GM BEDFORD REMOVAL ACTION SITE SOURCE CONTROL PLAN, ADDENDUM NO. 2

GM POWERTRAIN BEDFORD FACILITY BEDFORD, INDIANA

CONESTOGA-ROVERS & ASSOCIATES

**AREA NORTH OF AOI 4 - COLLECTION
SYSTEMS 'A', 'B' AND 'C' PLAN & SECTIONS**

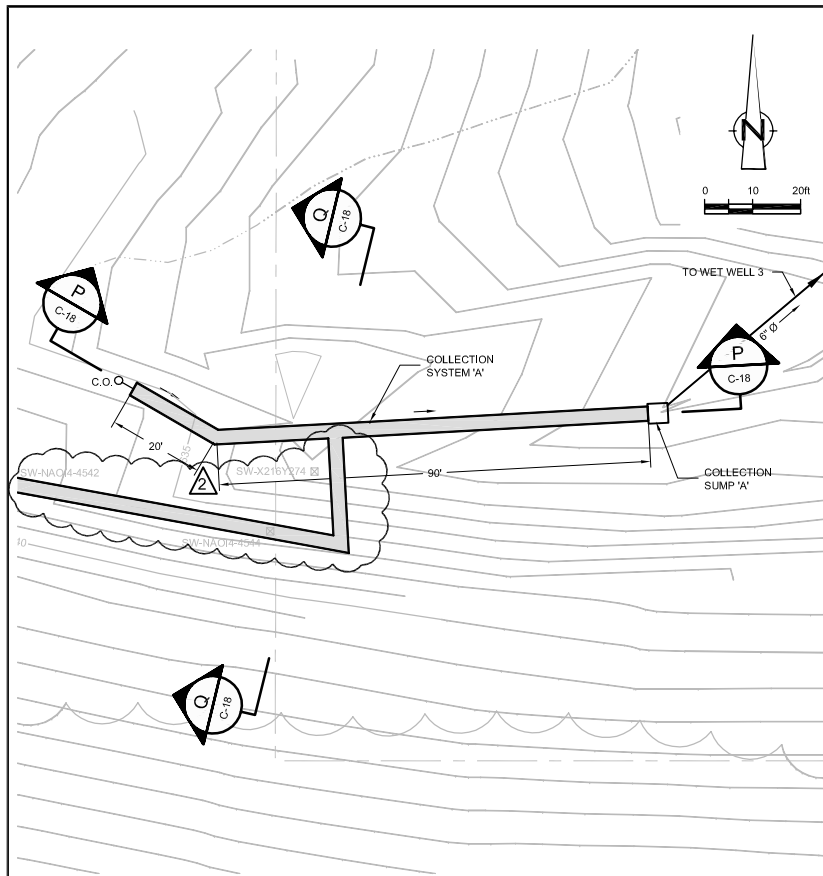
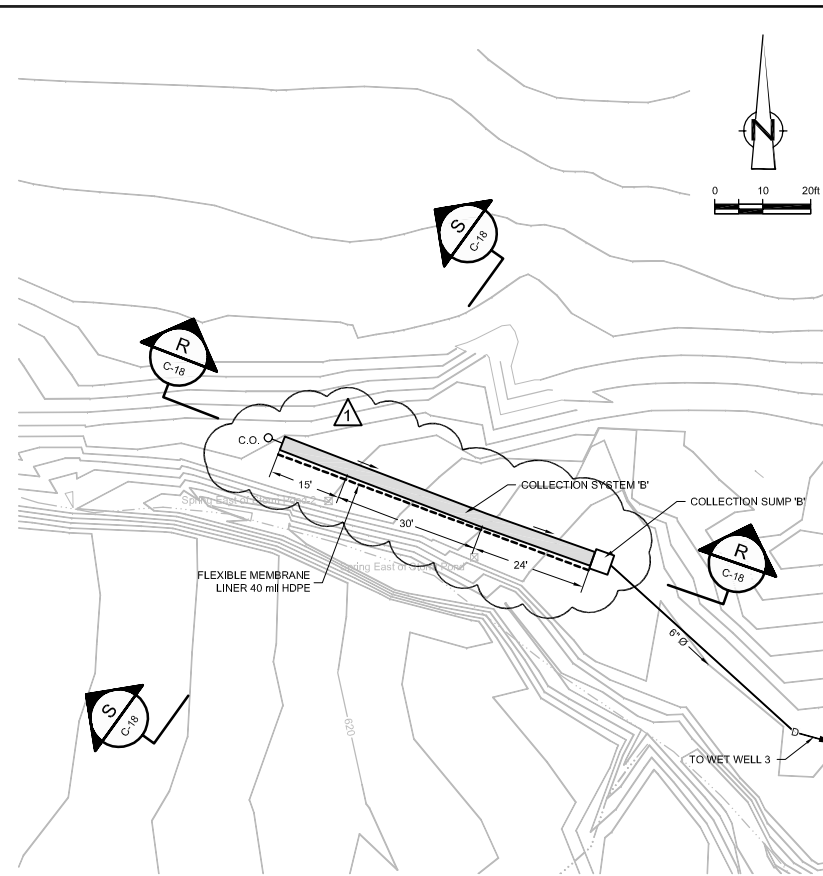
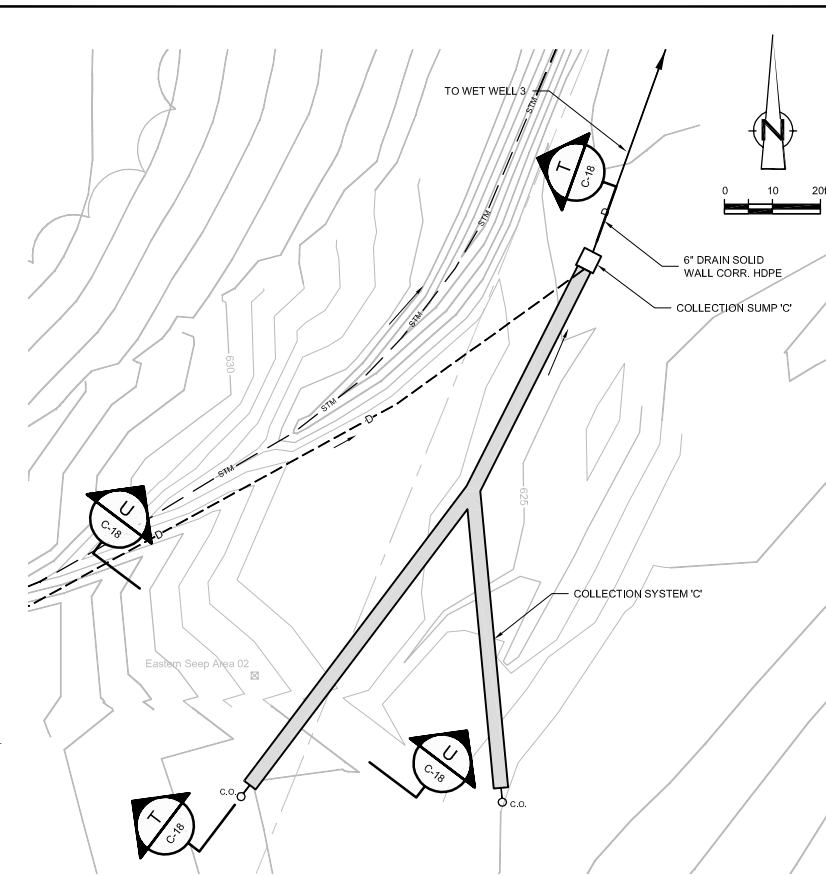
NO	Revision	Date	Initial
1	COLLECTION SYSTEM "B" PLAN AND SECTION POSITION OF PROPOSED EXTRACTION TRENCH REVISED	AUG 20, 2004	AW
2	ADDITIONAL SEEP COLLECTION AREAS	OCT 15, 2004	CRH

GM BEDFORD REMOVAL ACTION SITE SOURCE CONTROL PLAN		
ADDENDUM NO. 2		
AREA NORTH OF AOI4 COLLECTION SYSTEM DETAILS

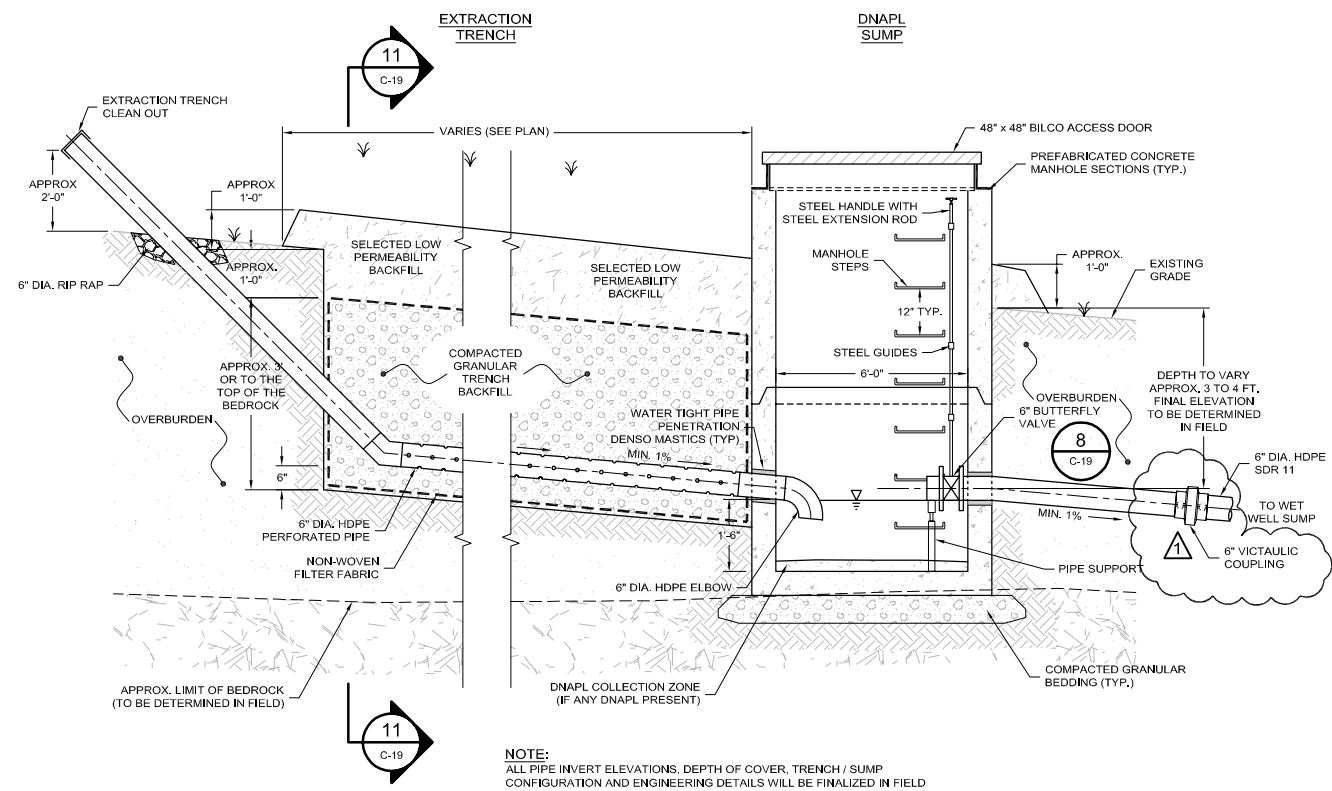
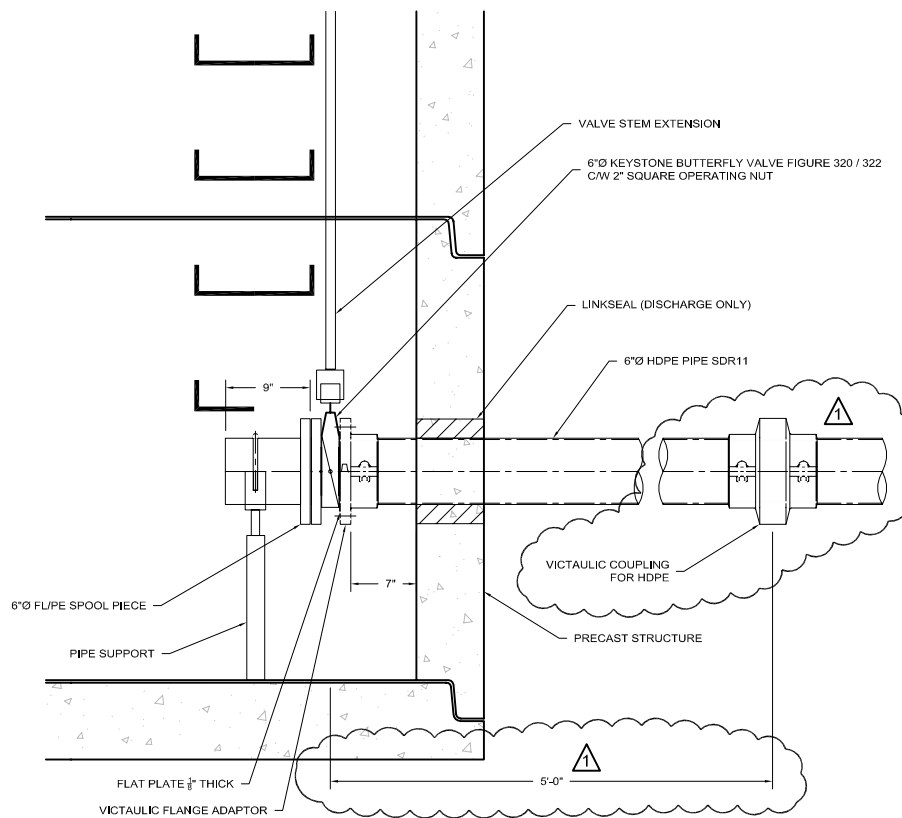
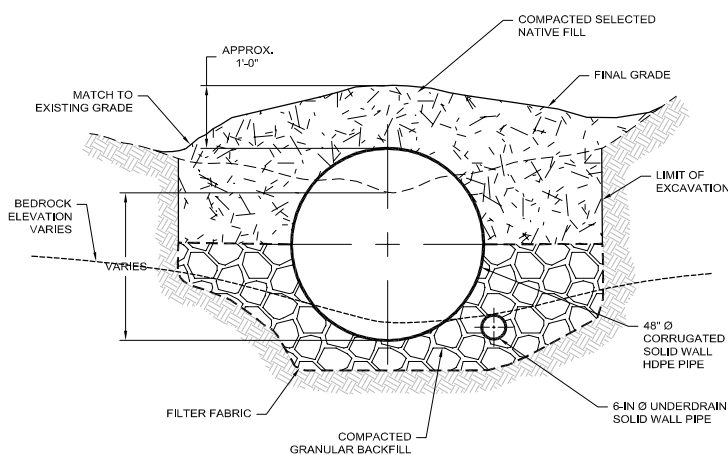
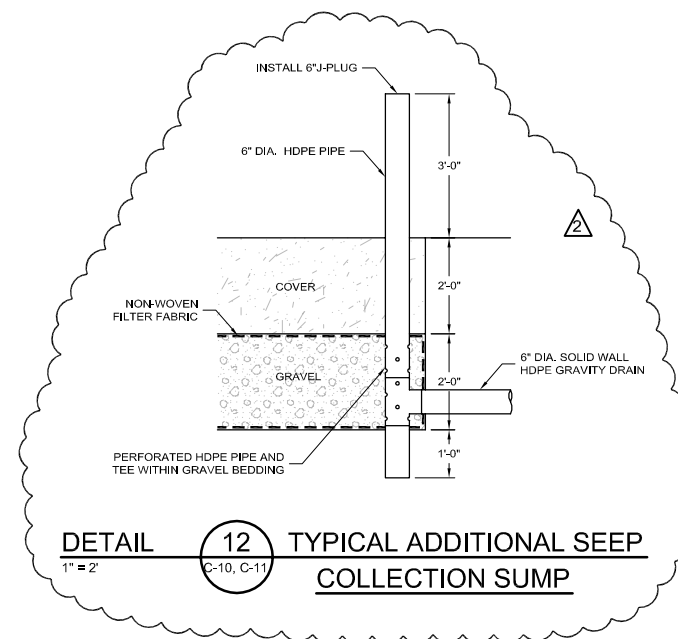
NO	Revision	Date	Initial
1	DETAIL 7 AND 8 VICTAULIC COUPLING FOR HDPE AND DIMENSIONS ADDED	AUG 20, 2004	AW
2	ADDED DETAIL 12 TYPICAL ADDITIONAL SEEP COLLECTION SUMP*	OCT 1, 2004	CRH

FRONT ELEVATION
DETAIL 3 INLET HEADWALL
1/2"=1' C-04, C-09

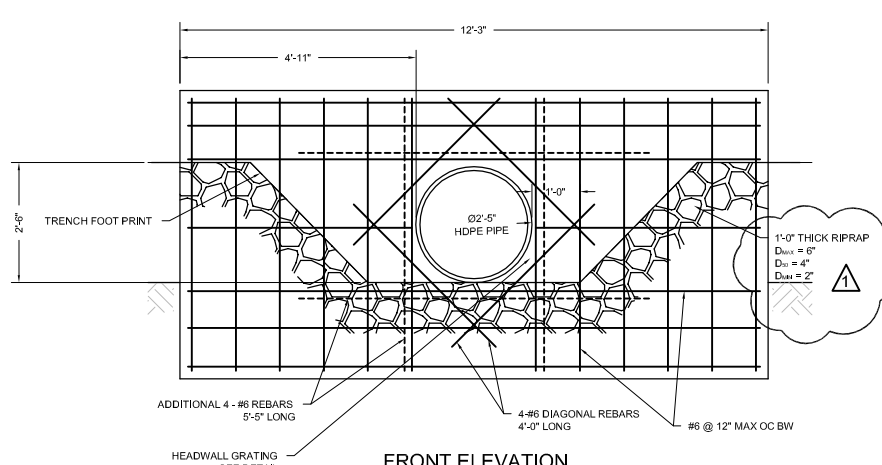
NO	Revision	Date	Initial
1	DETAIL 3 FRONT ELEVATION AND CROSS SECTION TEXT ADDED	AUG 20, 2004	AW

SECTION I
1/2"=1' S-02

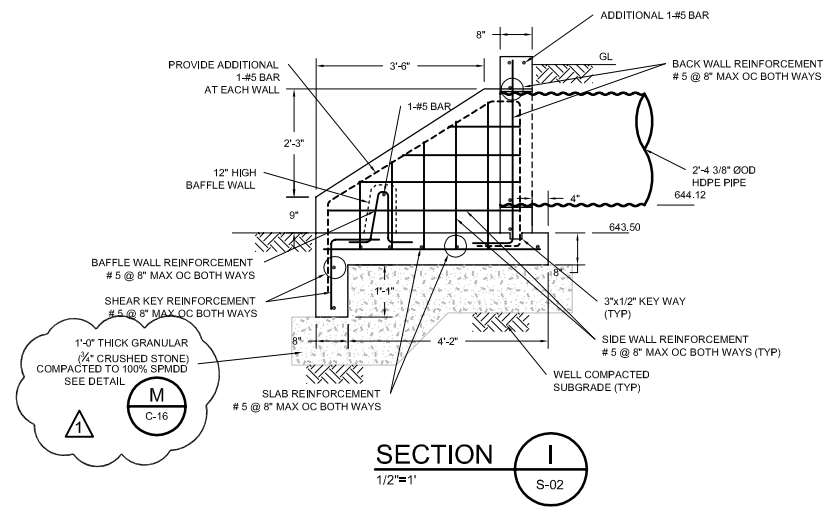
NO	Revision	Date	Initial
1	SECTION I TEXT ADDED	AUG 20, 2004	AW

**GM BEDFORD REMOVAL ACTION
SITE SOURCE CONTROL PLAN**
ADDENDUM NO. 2
MGT LIFT STATION

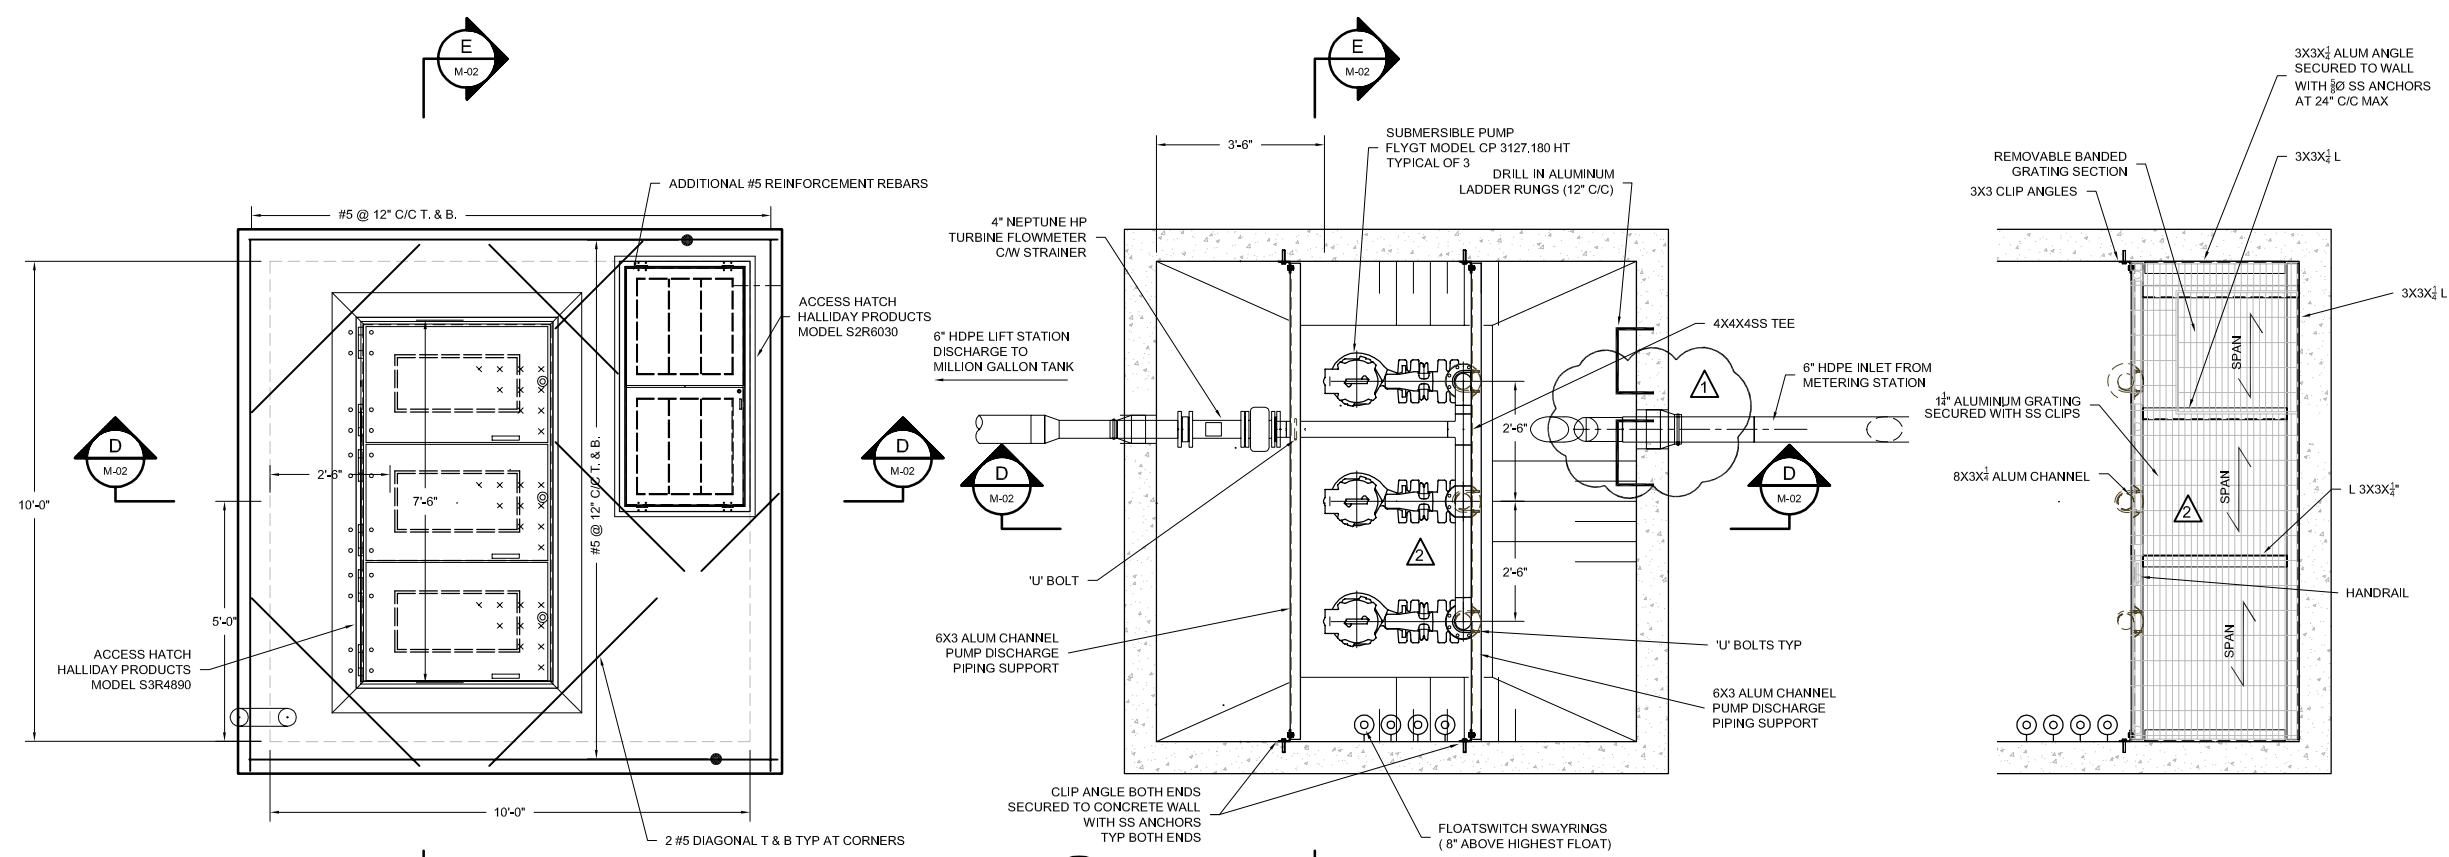
NO	Revision	Date	Initial
1	DETAIL 4 AND SECTION D HDPE ELBOW 90° ADDED AS SHOWN	AUG 20, 2004	AW
2	REVISED PIPING AND PLATFORM TO REFLECT AS CONSTRUCTED ROOF SLAB	OCT 22, 2004	DP

POWER DISTRIBUTION SINGLE LINE DIAGRAM

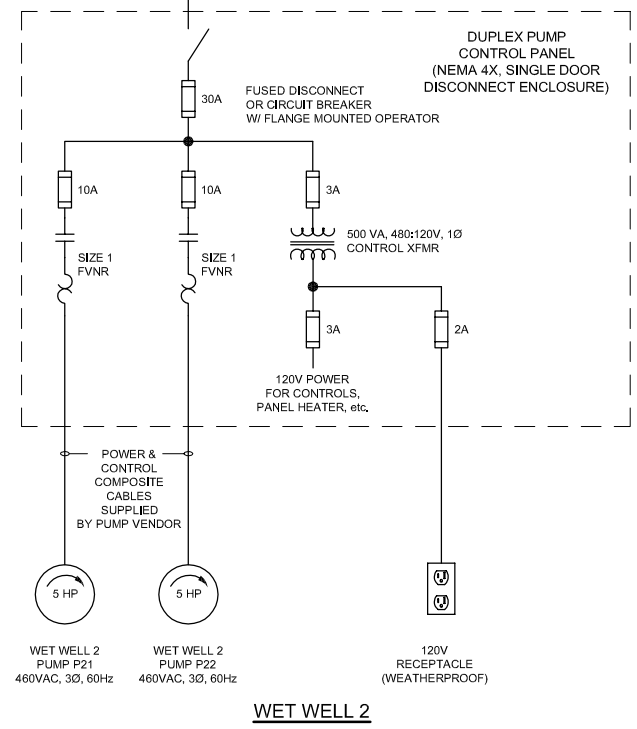
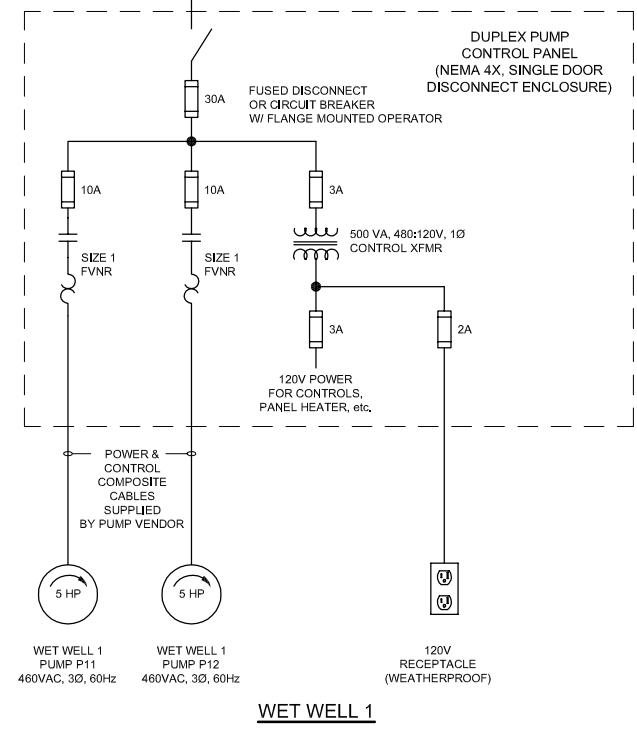
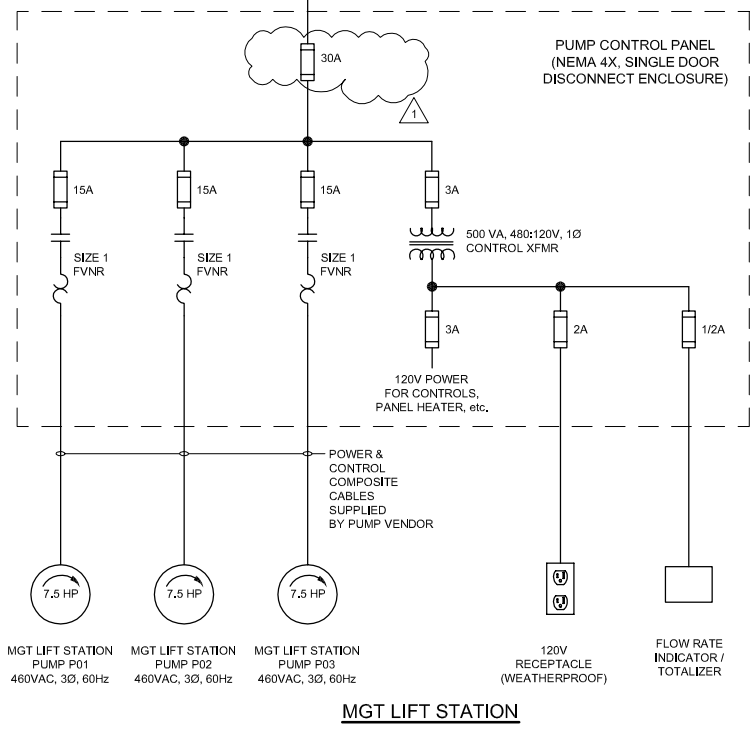
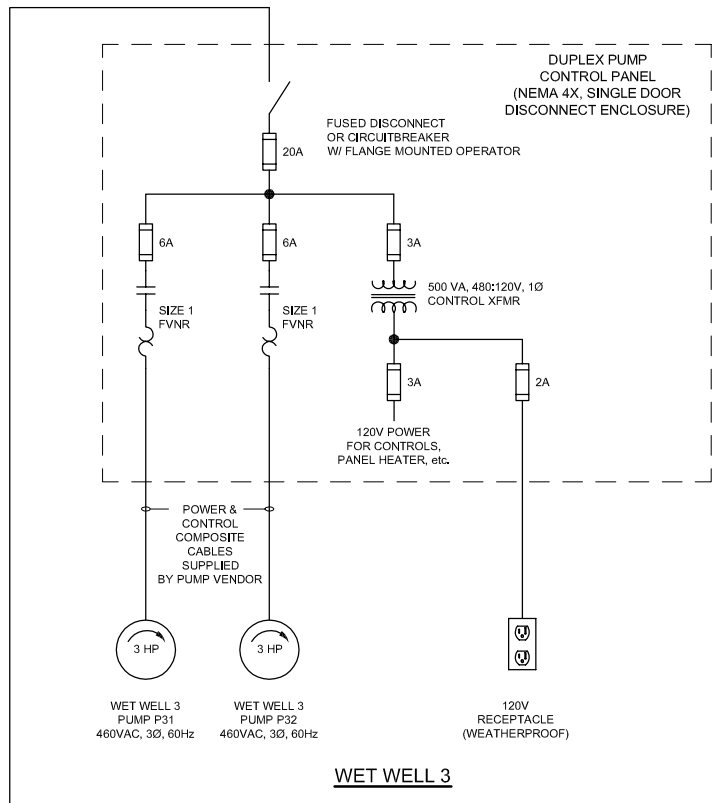
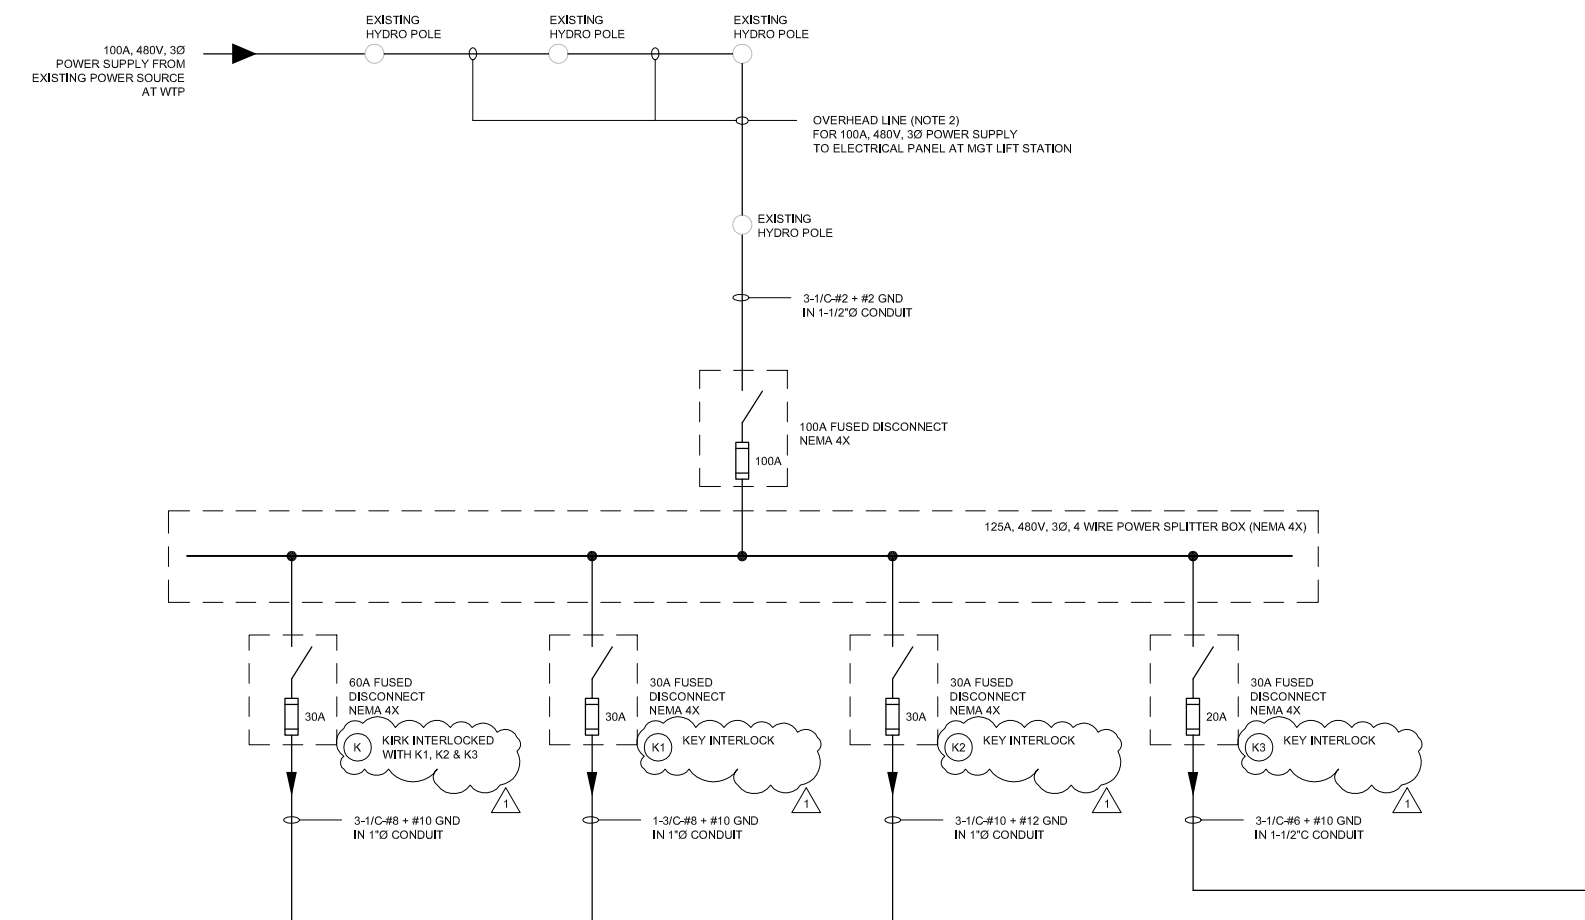
NO	Revision	Date	Initial
1	ADDED KIRK INTERLOCKS	AUG 17, 2004	CRH

3) KIRK INTERLOCKS TO BE ADDED FOR THE FUSED DISCONNECTS AS SHOWN, TO ENSURE THE DISCONNECT SWITCH FOR MGT LIFT STATION WILL NOT BE ABLE TO TURN OFF IF ANY ONE OF THREE DISCONNECT SWITCHES FOR WET WELLS IS ON.
